**Subject: Transmittal of the Navy Response to Comments on the Draft RI/FS Aquifer  
Testing Work Plan, Naval Air Station, Alameda  
Navy CLEAN Contract No. N62474-88-D-5086, Contract Task Order 0316**

**RESPONSES TO REGULATORY AGENCY AND COMMUNITY COMMENTS  
REMEDIAL INVESTIGATION/FEASIBILITY STUDY AQUIFER TESTING WORK PLAN  
NAVAL AIR STATION, ALAMEDA**

**RESPONSE TO COMMENTS FROM DTSC ON DRAFT REMEDIAL  
INVESTIGATION/FEASIBILITY STUDY, AQUIFER TESTING WORK PLAN  
NAVAL AIR STATION ALAMEDA**

NAVAL AIR STATION ALAMEDA  
ALAMEDA, CALIFORNIA  
SITE 2  
PROPOSED AQUIFER TEST WELL LOCATIONS

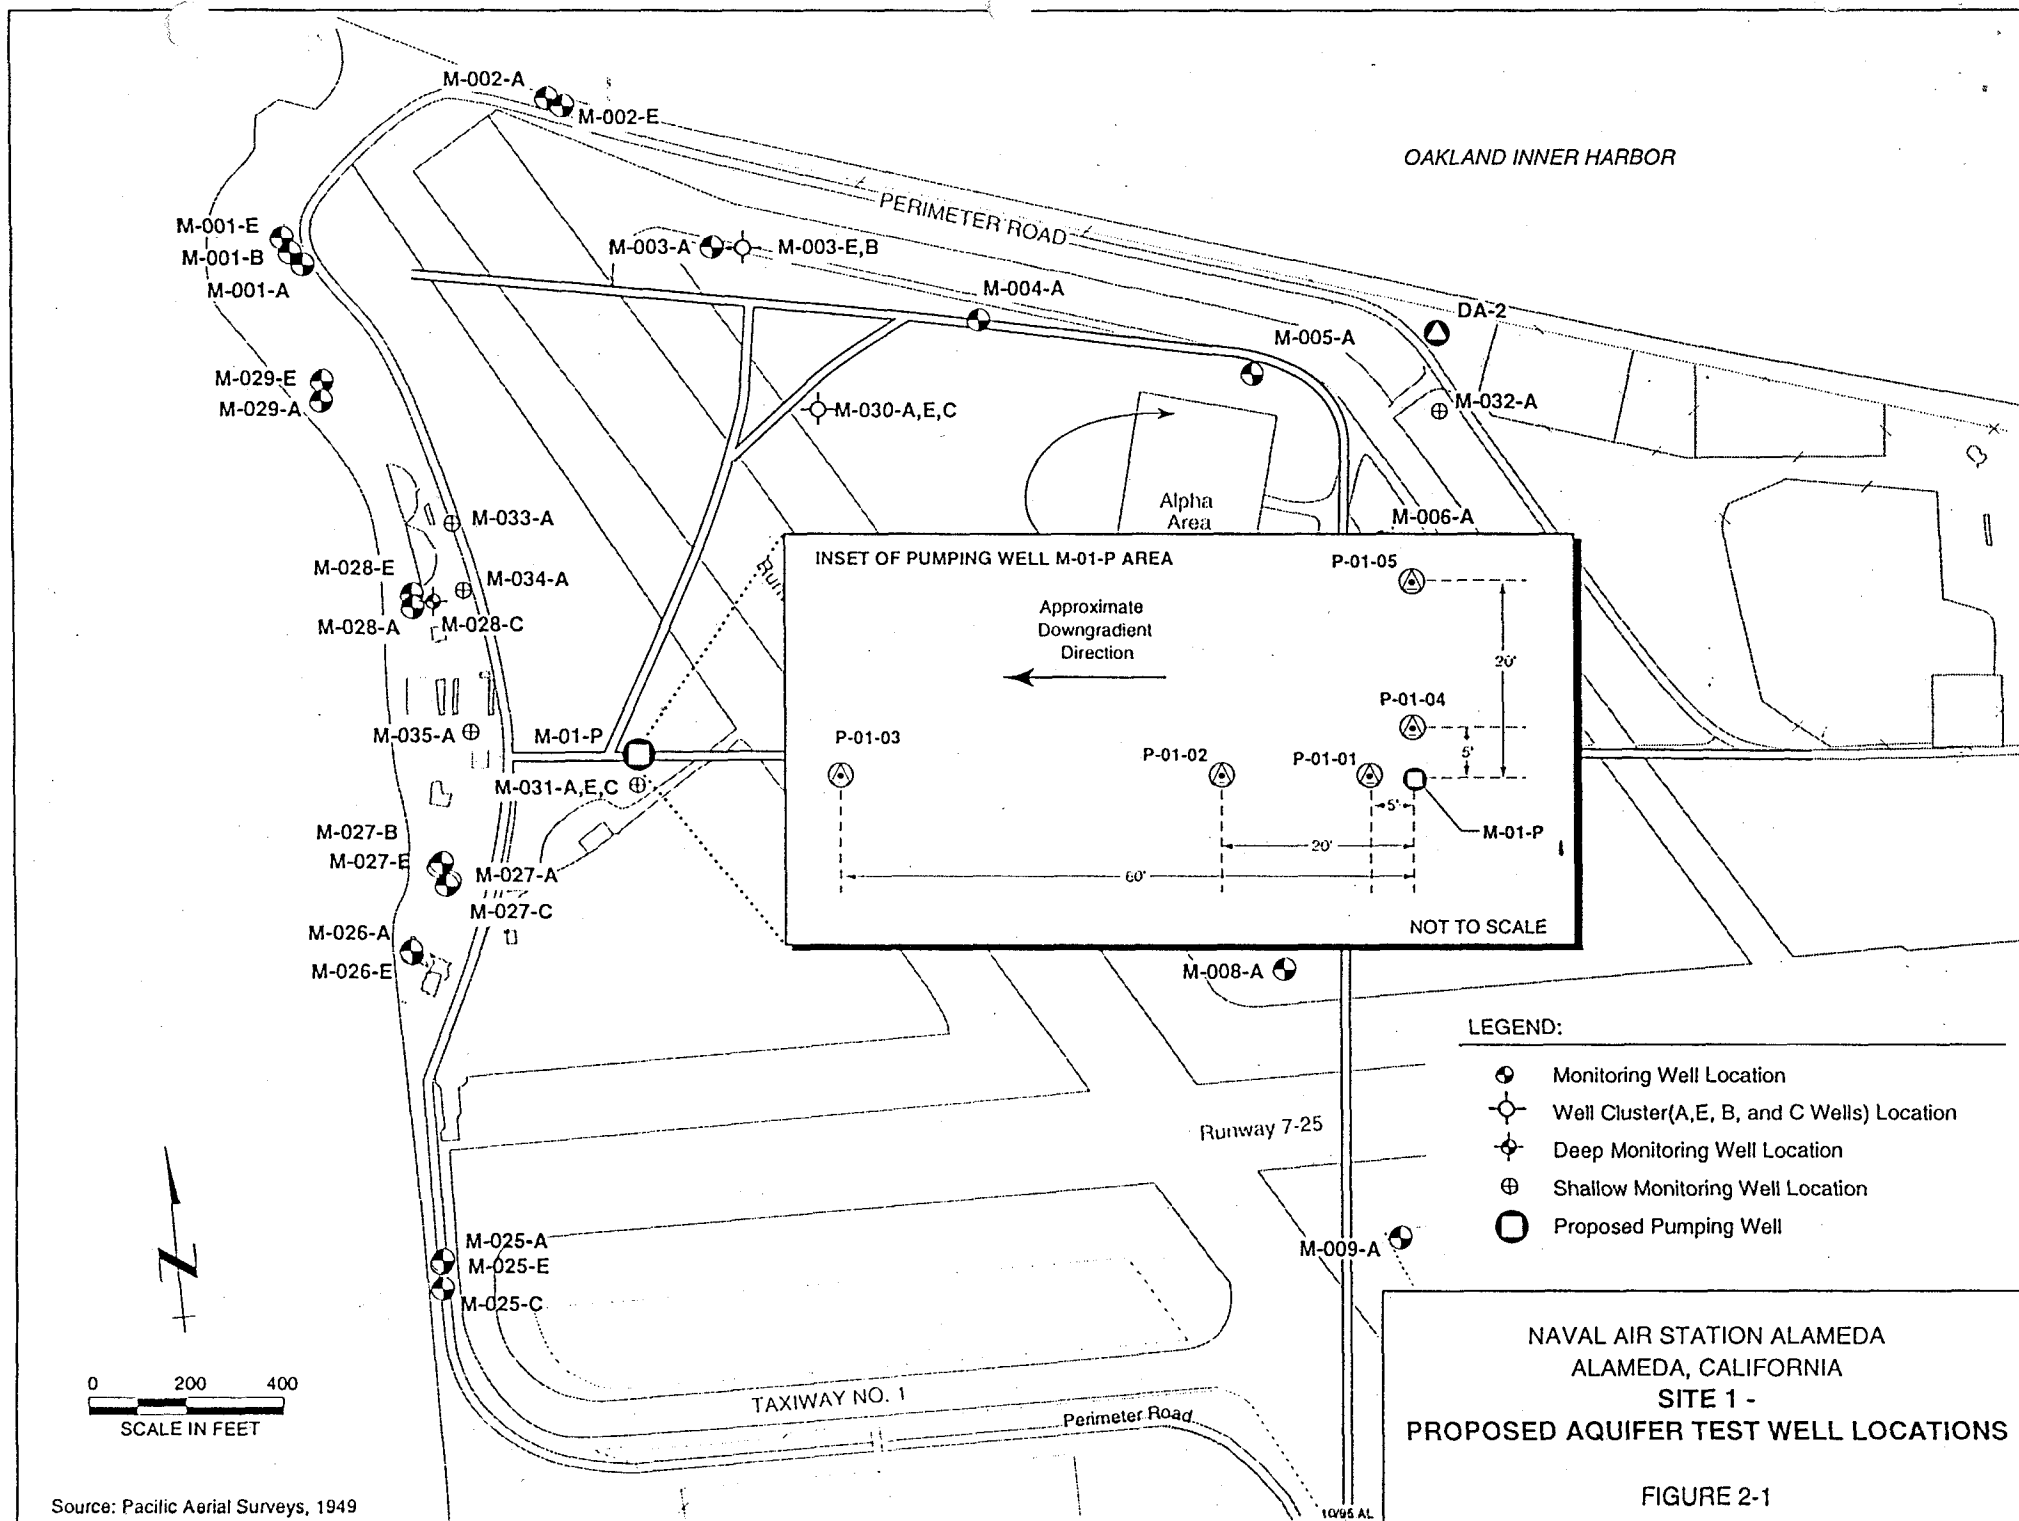
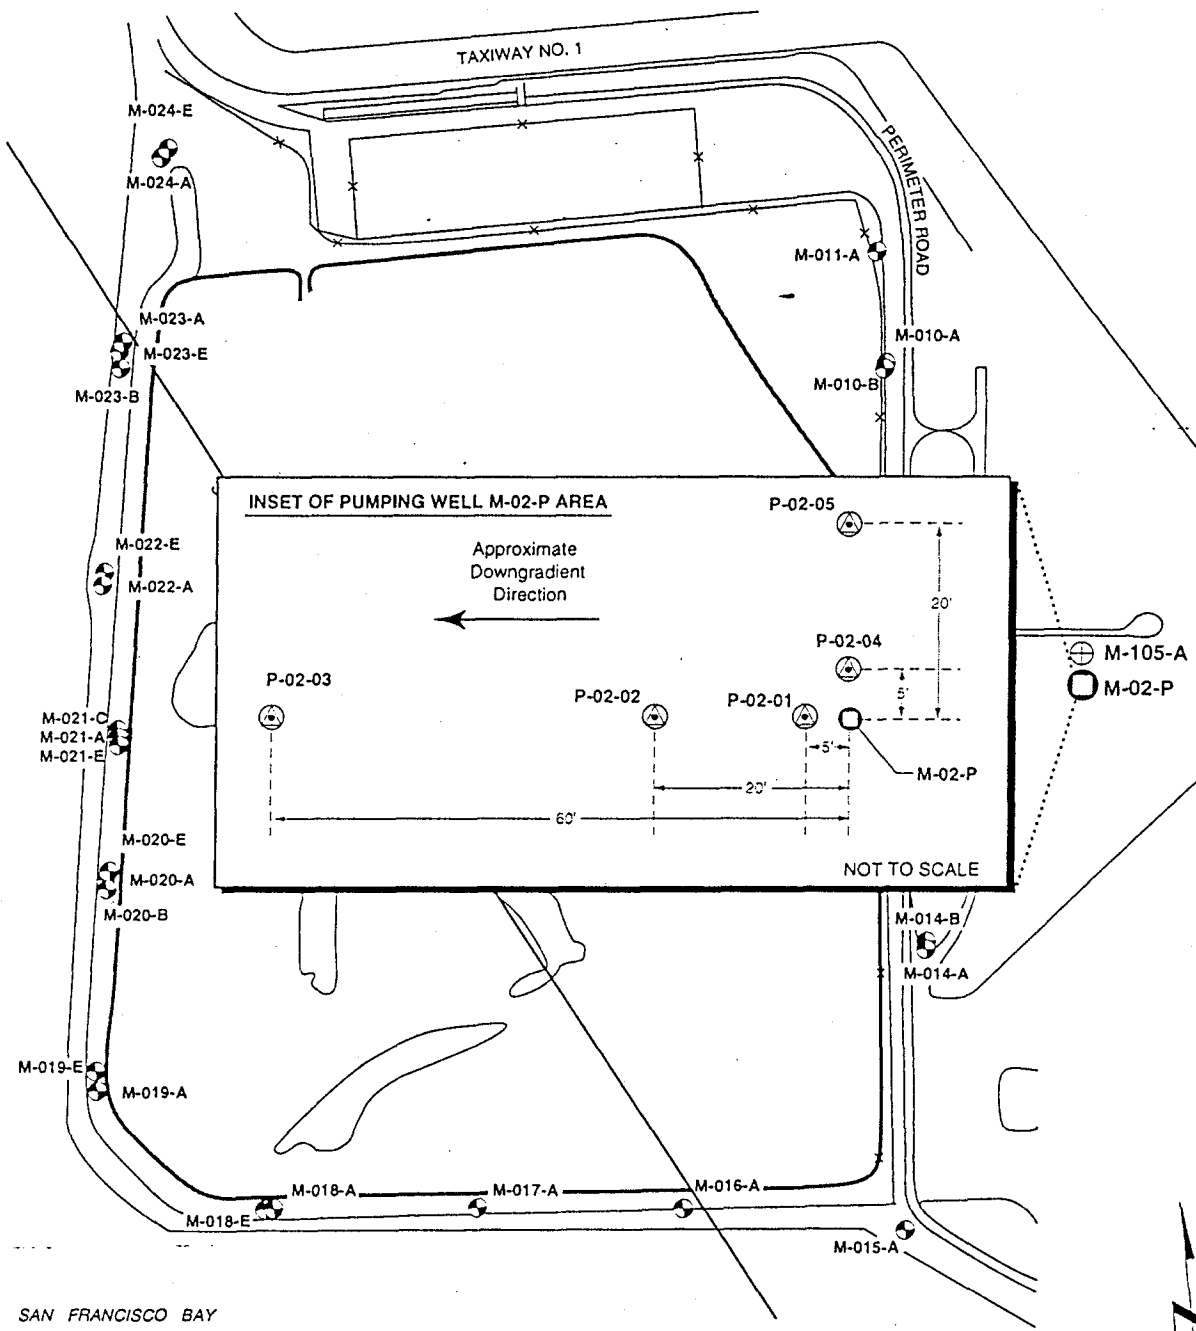
Comment 8: Page 2-8, Section 2.1.1, Paragraph 2. *Please add Well Monitoring 105-B to Figure 2-2.*

*Comment 12: Figures 2-1 and 2-2. Add the site borders to each figures.*

The pumping wells originally proposed in the draft RI/FS aquifer testing work plan may not be effective in creating adequate drawdown of the water table. The proposed well design has been reevaluated using the 2-dimensional model, Flow Path 5.1. The revised proposed well design proposed for this aquifer test will be presented and the proposed well locations are shown on Figures 2-1, 2-2, 2-3, and 2-4 attached to this response document.

Response 12: Piezometer locations are shown on Figures 2-1 through 2-4 attached to this response document, and will be provided on the figures in the final work plan (see also response to comment number 3).

Response 8: Well M-105-B will be added to Figure 2-2.

Response 12: Appropriate site borders will be added to these figures.

FIGURE 2-4

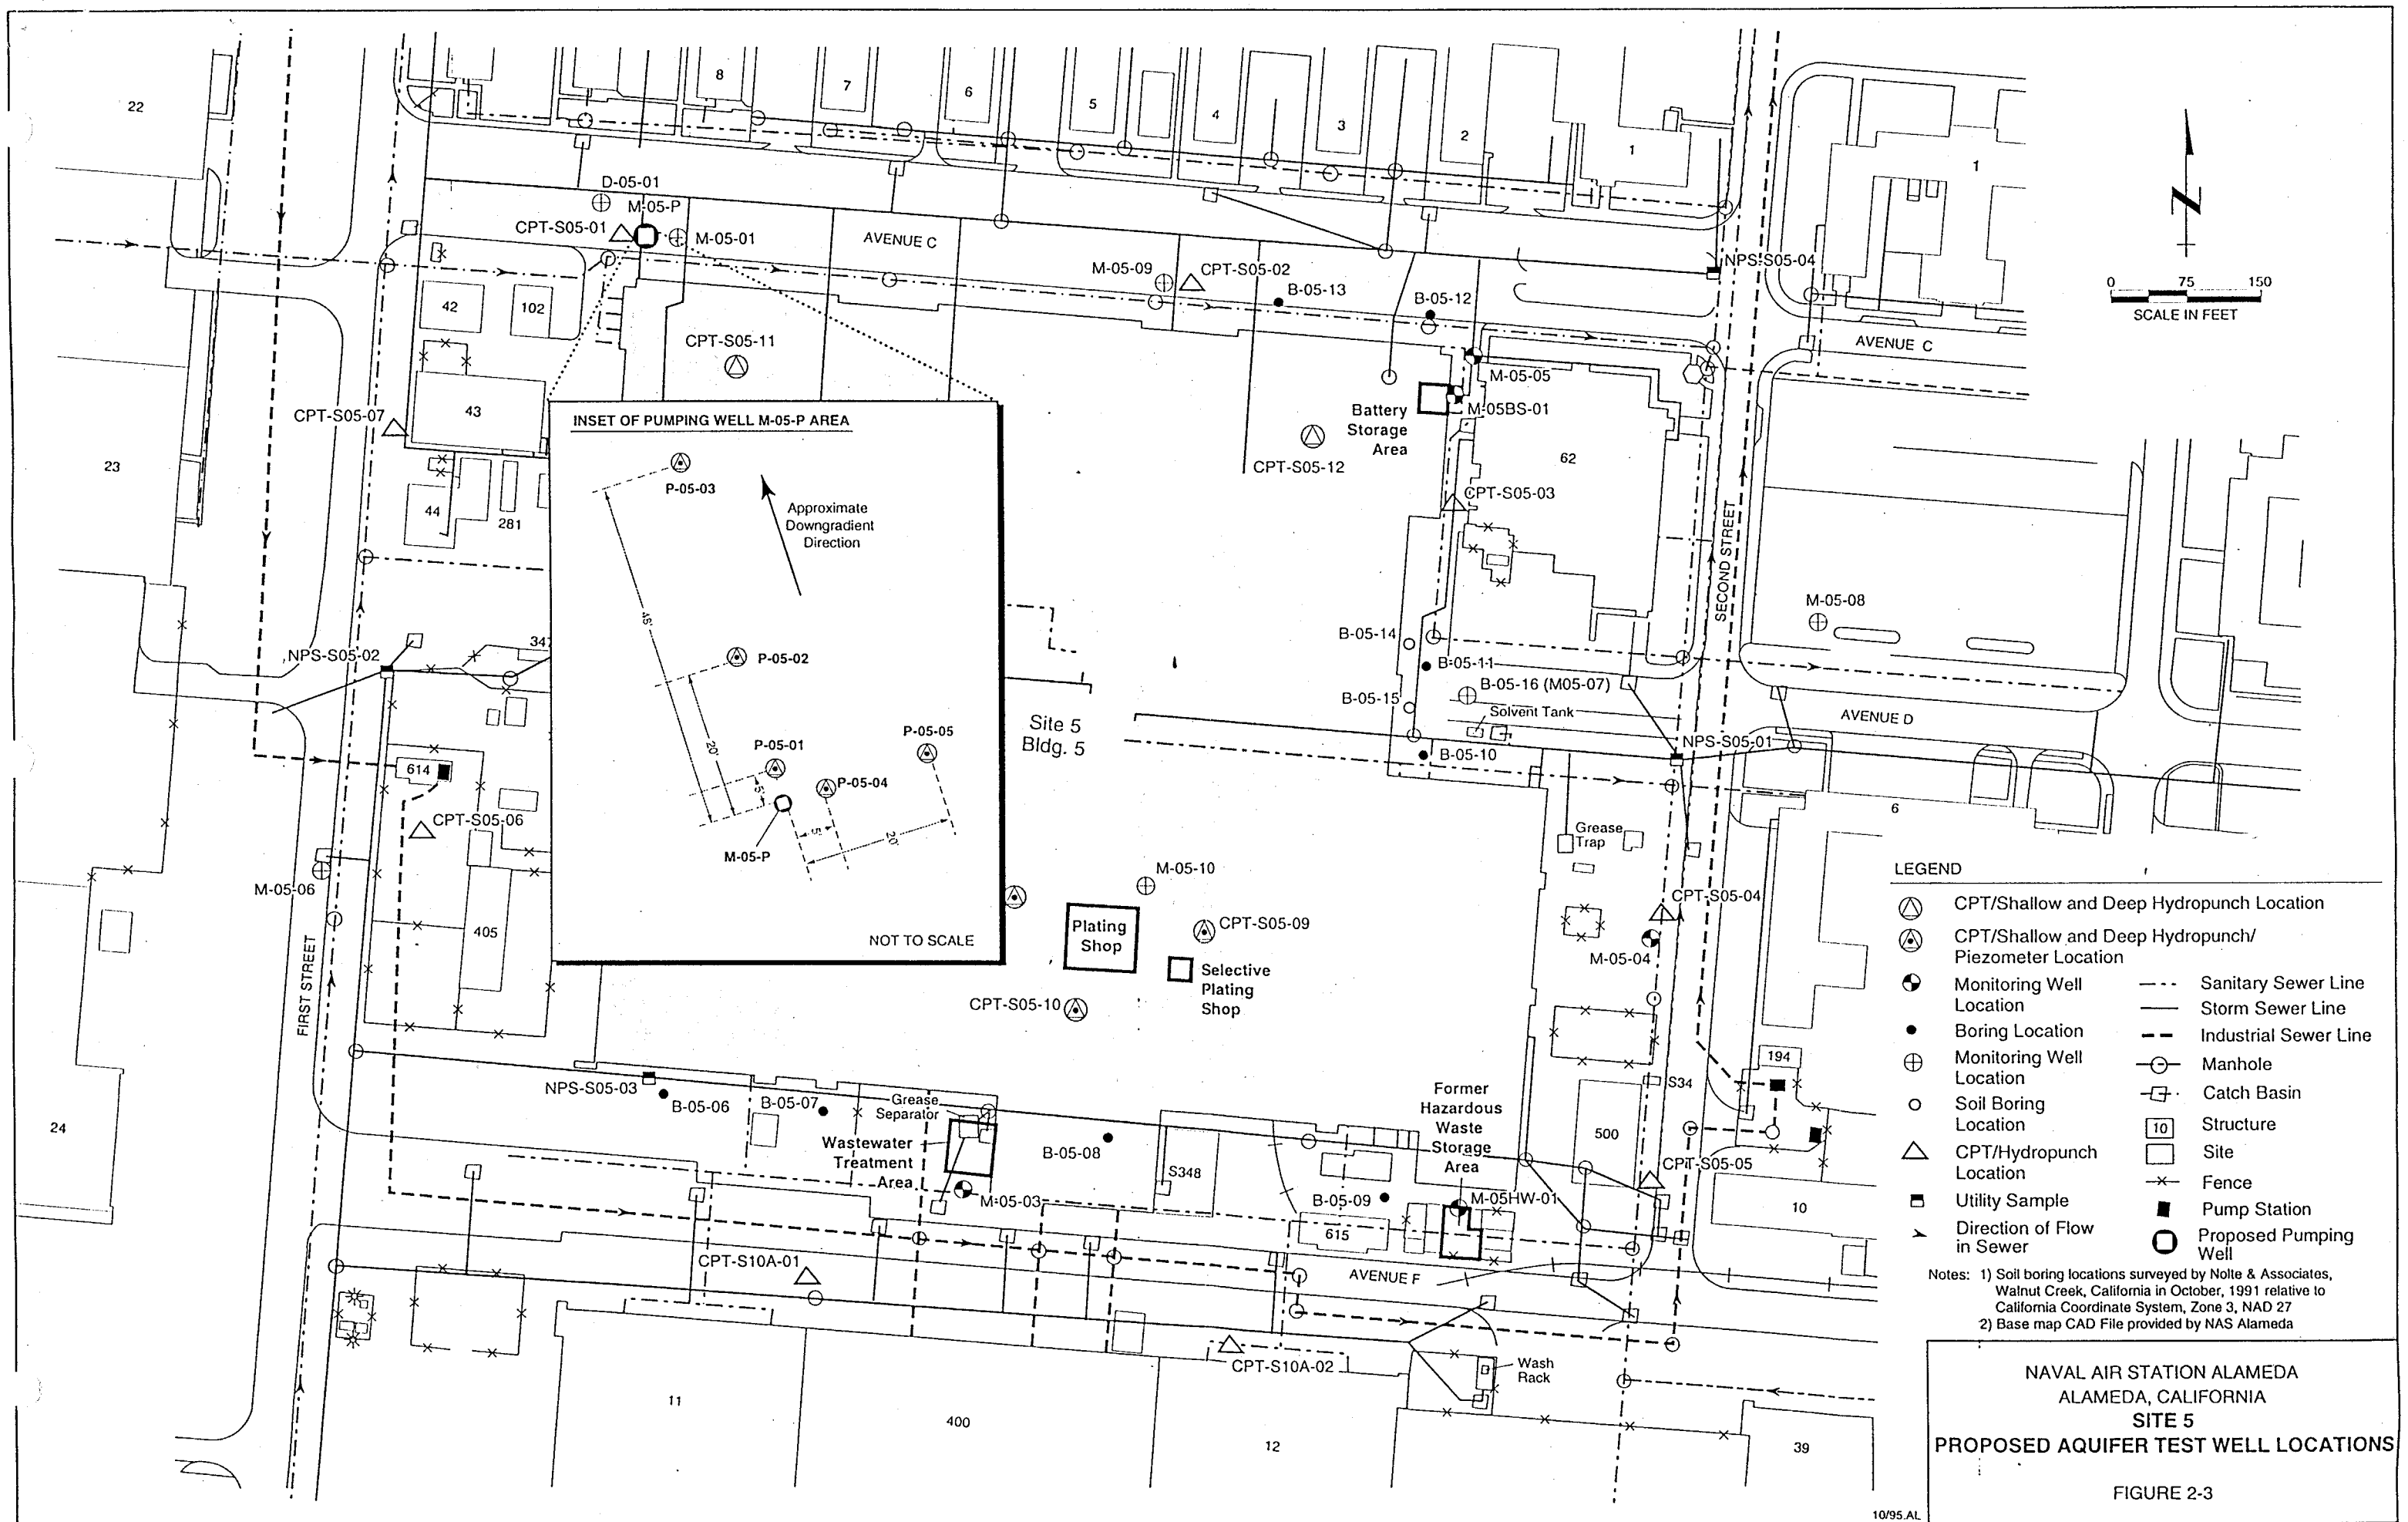
Comment 12: Page 2-13, third paragraph. Provide a figure showing locations of the proposed piezometers. Provide the appropriate text from the reference Lohman, 1972, to support locations of the observation wells. All new wells should follow DTSC's technical guidance document "Monitoring Well Design and Construction for Hydrogeologic Characterization, 1994" (see comment number one).
